PRODUCT BULLETIN #20811

TITLE: NCV8876 Datasheet Update

AFFECTED CHANGE CATEGORY(S): Datasheet Change

Figure 1. Typical Application

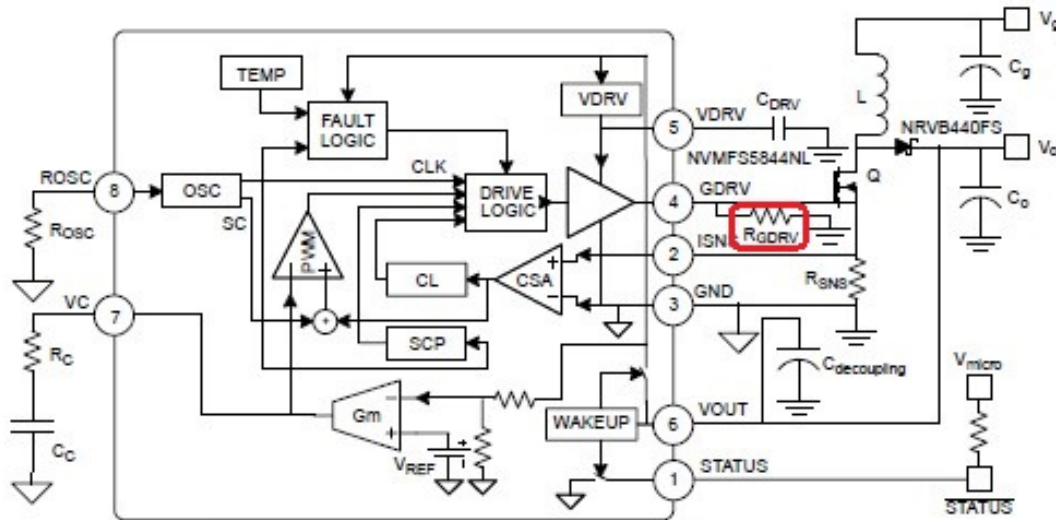
A good design practice recommendation of a MOSFET gate-source resistor on the PCB has been added to the datasheet. This resistor prevents the MOSFET from turning on in case of a floating gate.

The recommended resistor has been added to the application drawing on page 2, and a comment is added in the pin description. See below for highlighted changes to page 2.
